Solicitation No. 3450035790

Amendment No. 1

**BRYAN COUNTY
MAINTENANCE FACILITY**

REVISION SUMMARY – ADDENDUM #01

EVAPORATION POND SECTION B-B
N.T.S.

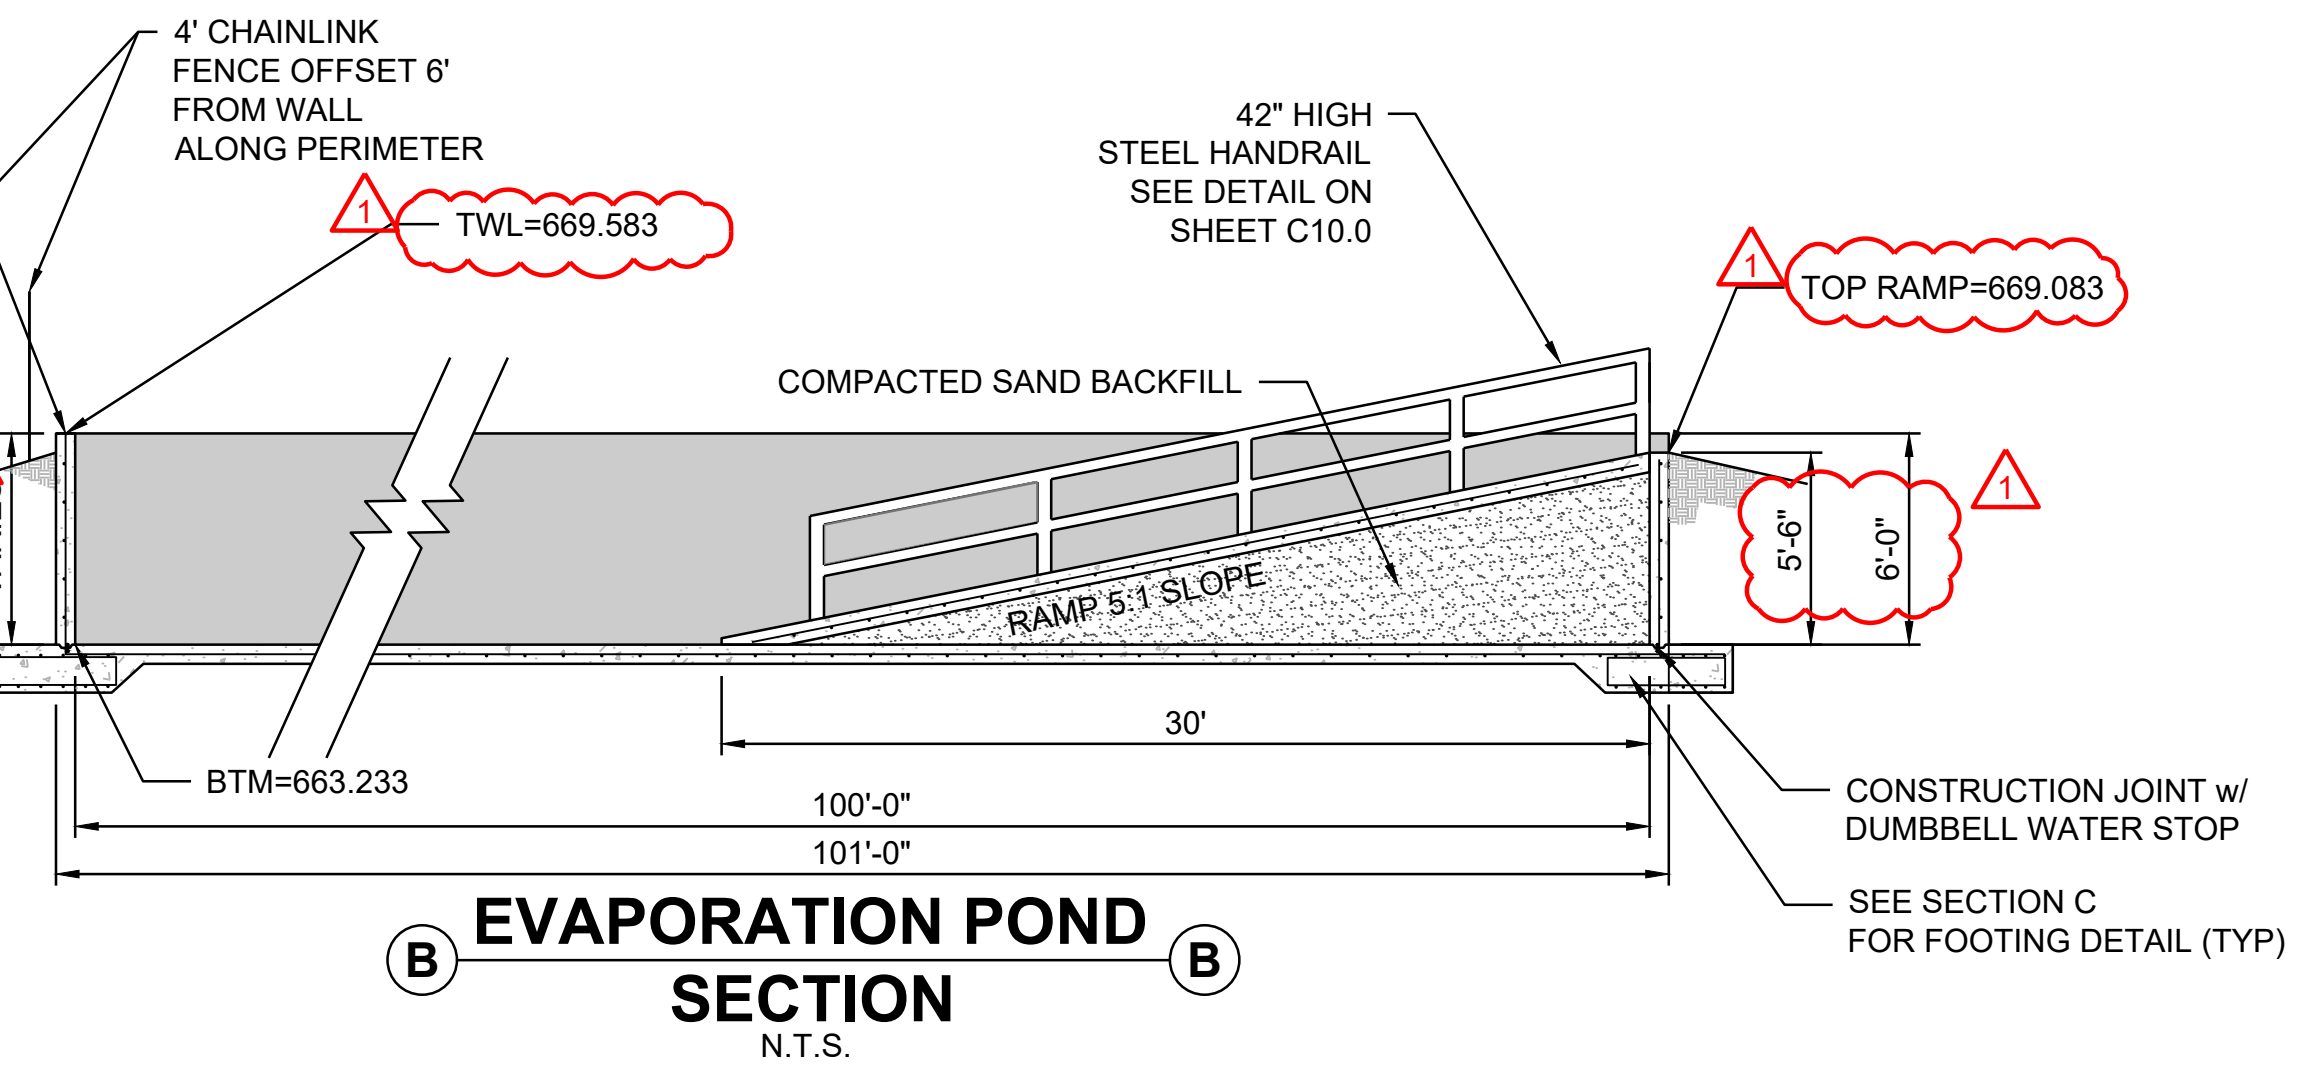
Q 8: Dimensions indicate a 10,000-sf pond. The pond notes indicate a surface area of 3,600 square feet. Please clarify. (C8.0)

2. UPDATED DESIGN NOTES FOR EVAPORATION POND.

A 8: Pond is 10,000 sf. C8.0 detail will be updated to correct pond information.

CONCRETE MIXING PAD SURFACE AREA = 3600 SF
REQ'D POND VOLUME = 10637.96 CF
ACTUAL POND VOLUME = 20000 CF
FREEBOARD = 4 FT
POND TOP = 669.583
POND BOTTOM = VARIES

1 | FLOOR PLAN
1/8" = 1'-0"

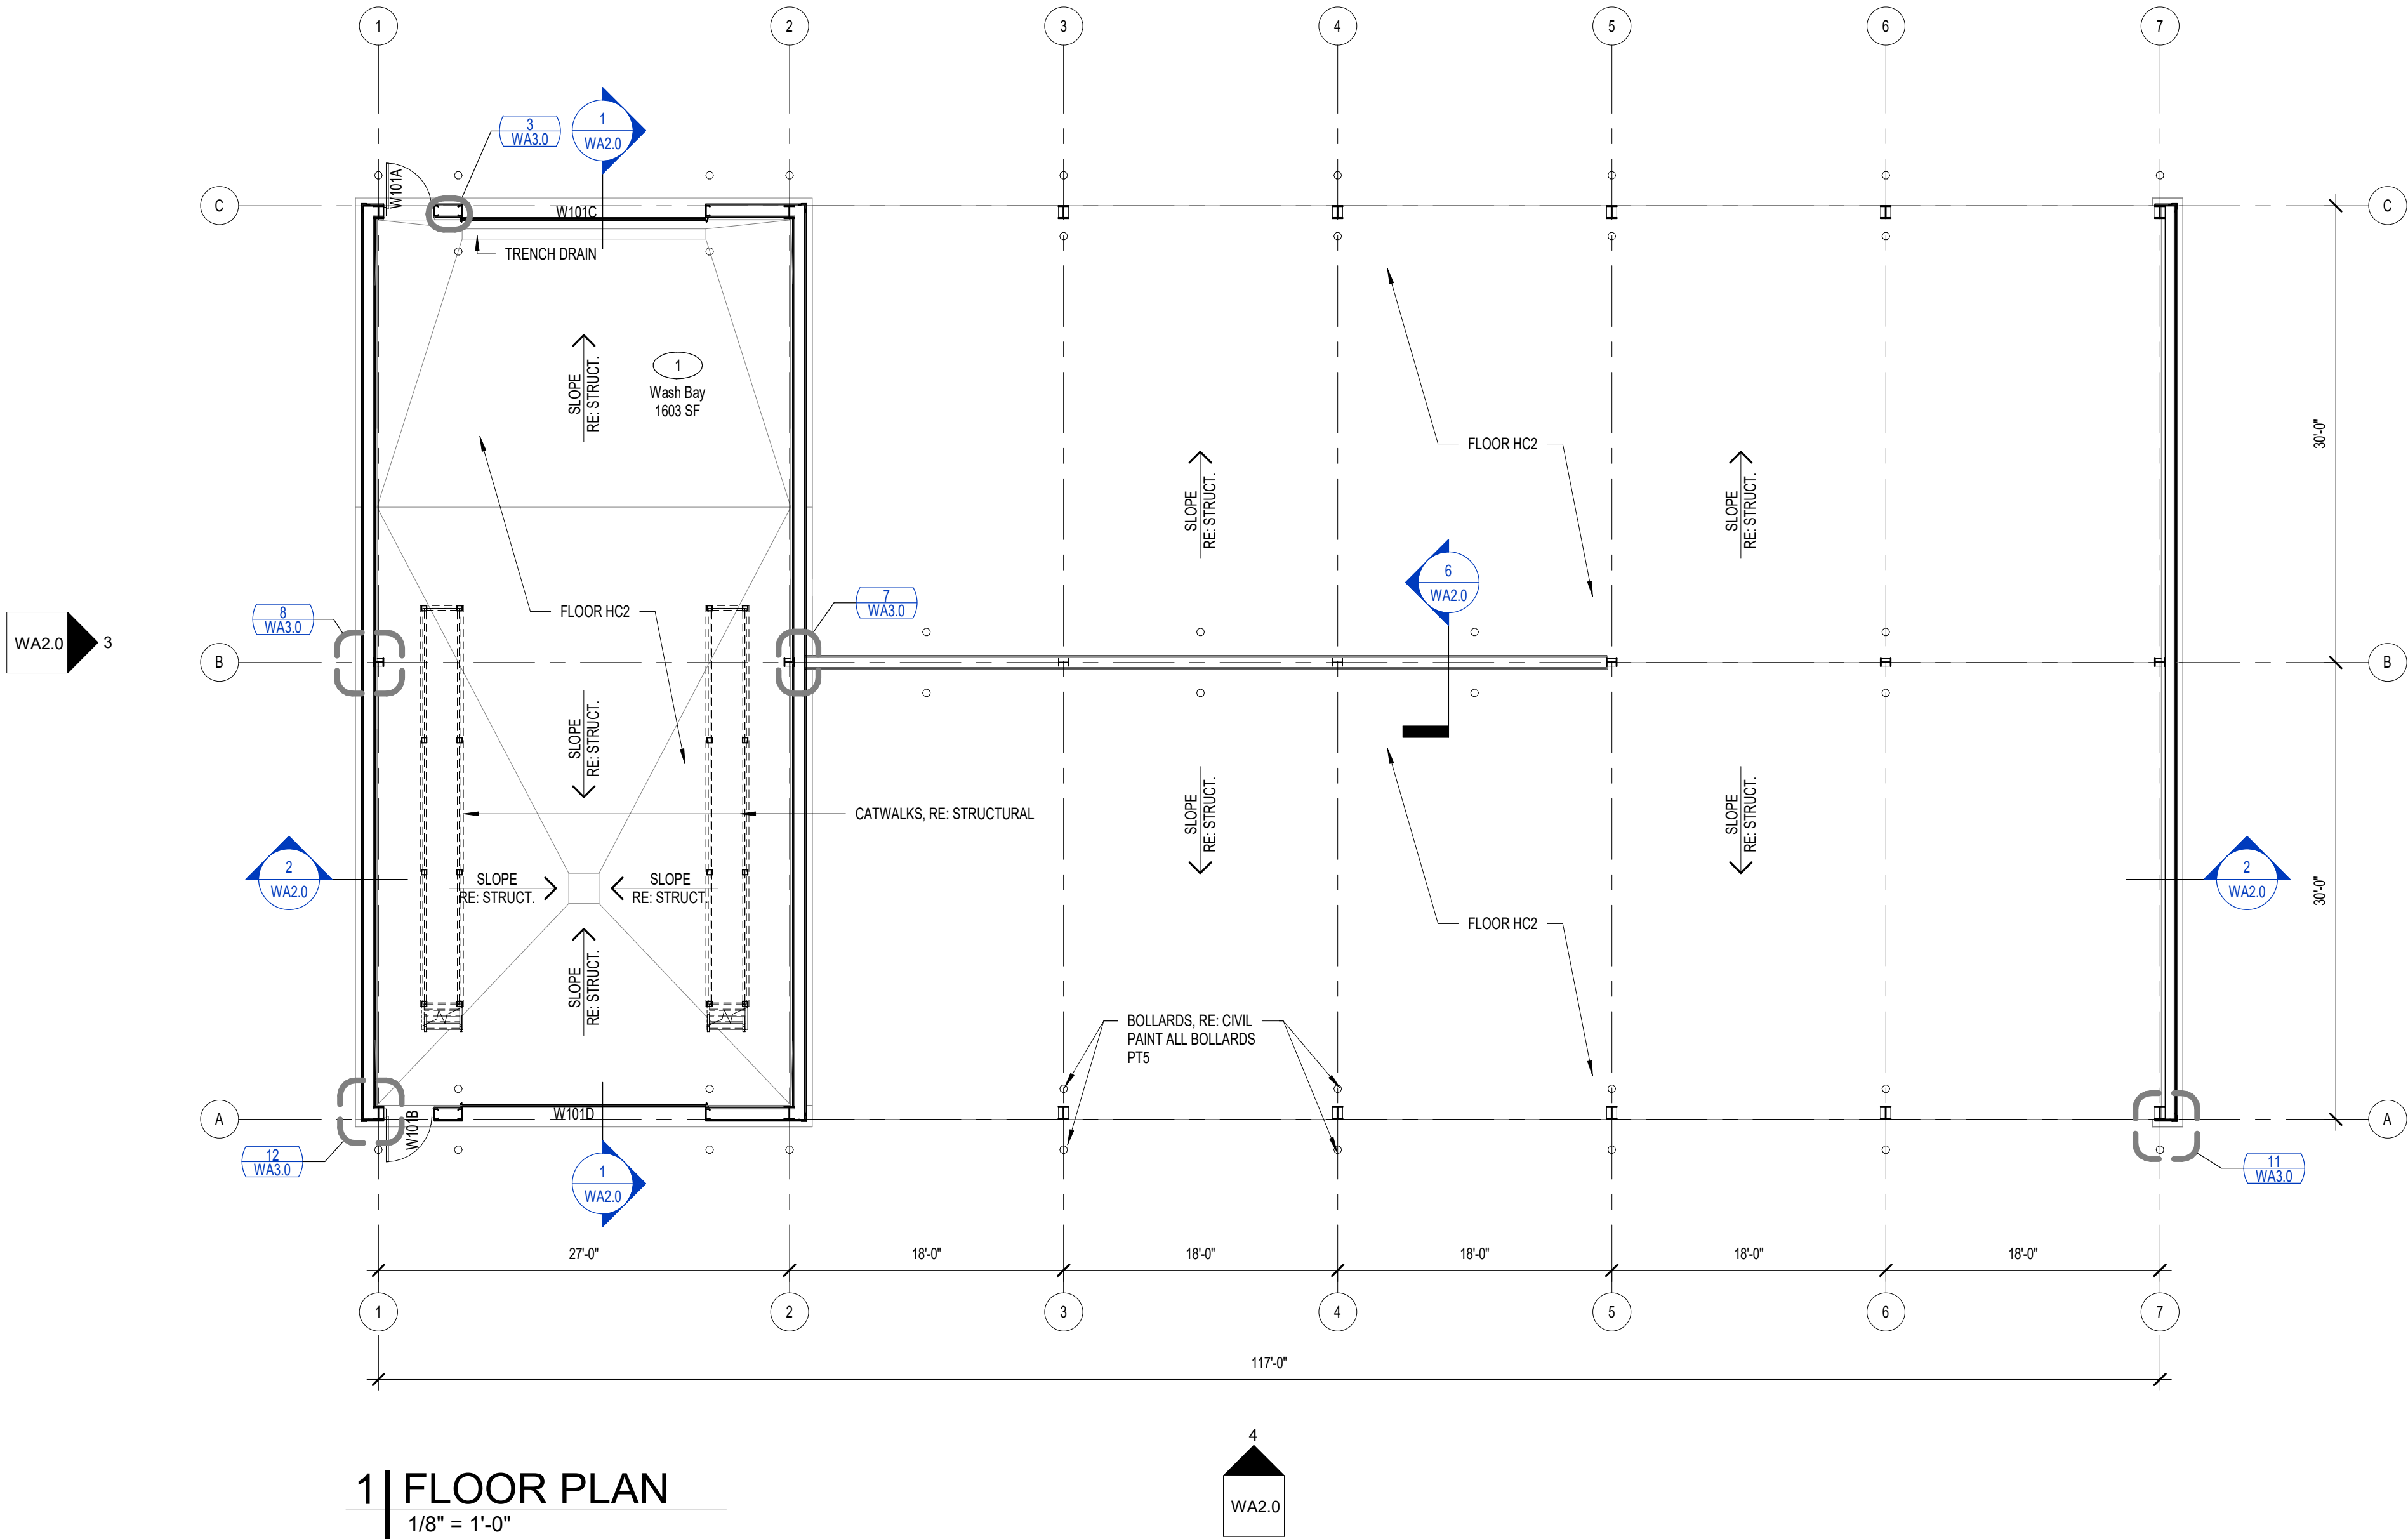
Q 23: Note states a "MONITORED FIRE ALARM REQUIRED AND IS PROVIDED." There are no FA plans for the building, and who is providing? Please clarify. (EA1.0)

A 23: This is the contractor's responsibility.

SHEET NAME
SHOP SHED MECHANICAL PLAN
SHEET
EM1.0

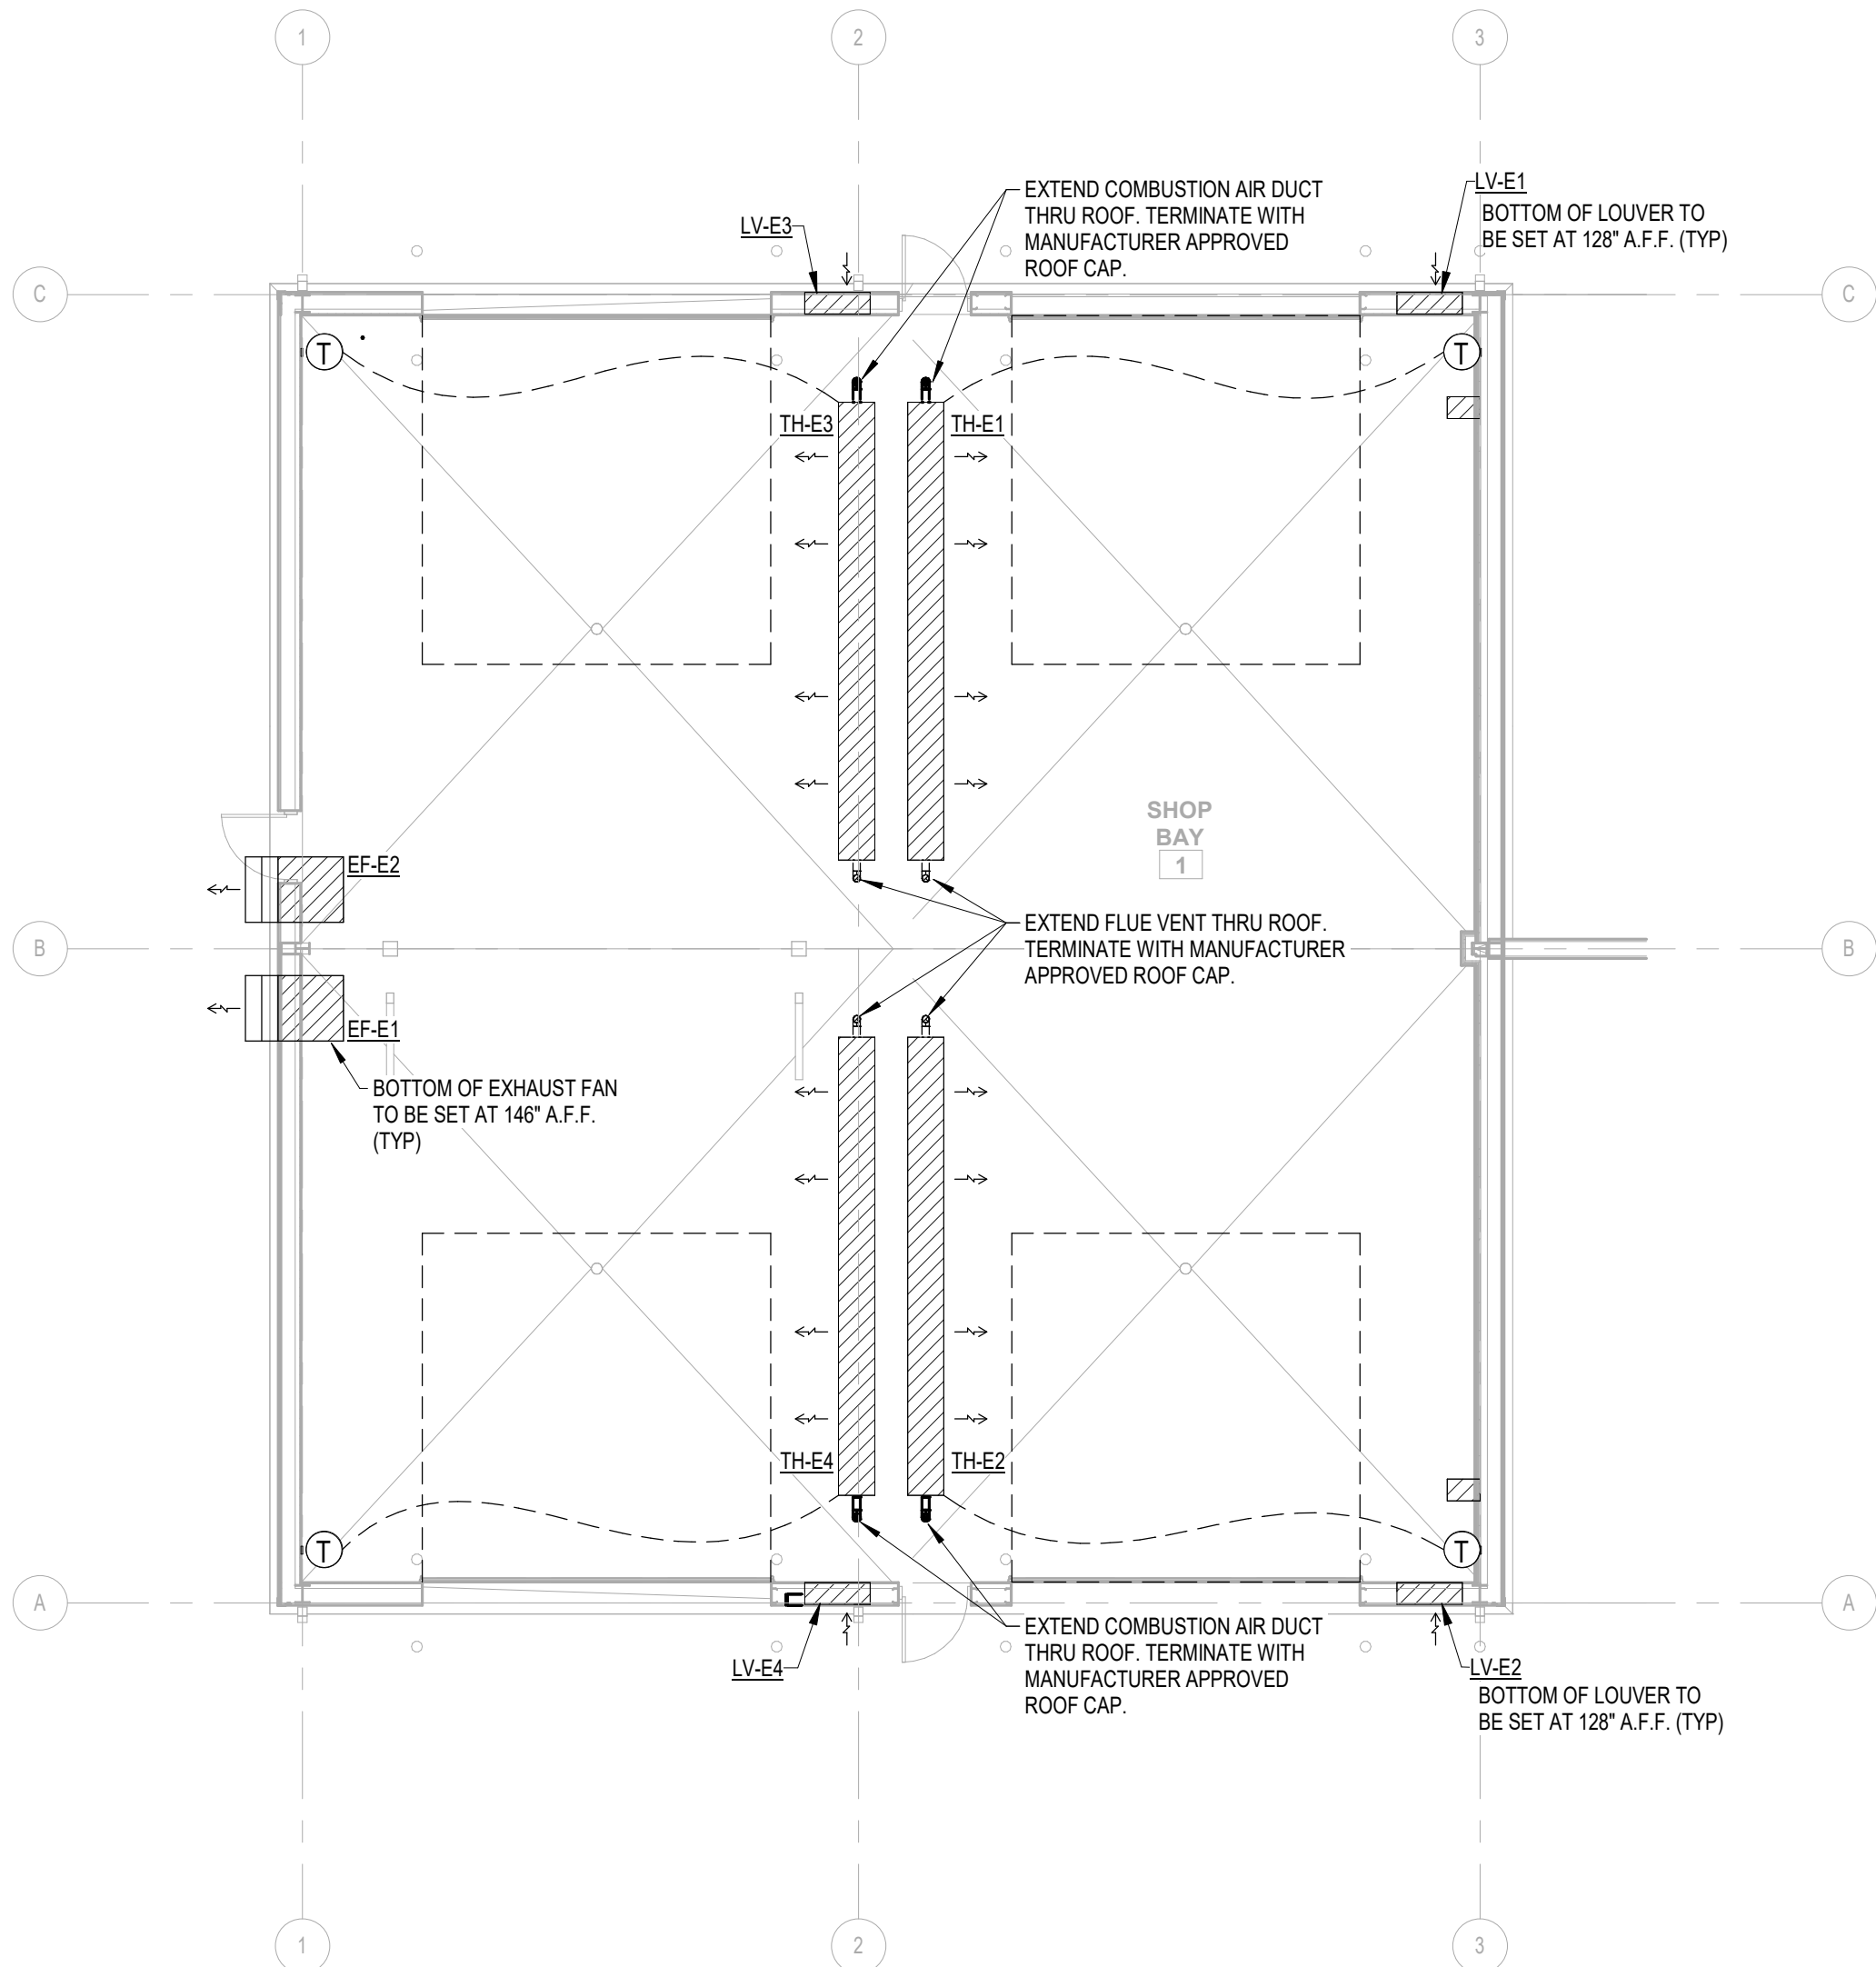
Q 25: The Plan denotes that there are two shop bays, but the plans show only one bay. Please clarify. (EM1.0).

1. SINGLE BAY TO DOUBLE BAY SHOP SHED, TITLE BLOCK CHANGED.

WHOLE SHEET CHANGED FROM SINGLE BAY TO DOUBLE BAY SHOP SHED.

A 25: Sheets EM1.0 and EP1.0 are being replaced. Two shop bays is what is needed for this project.
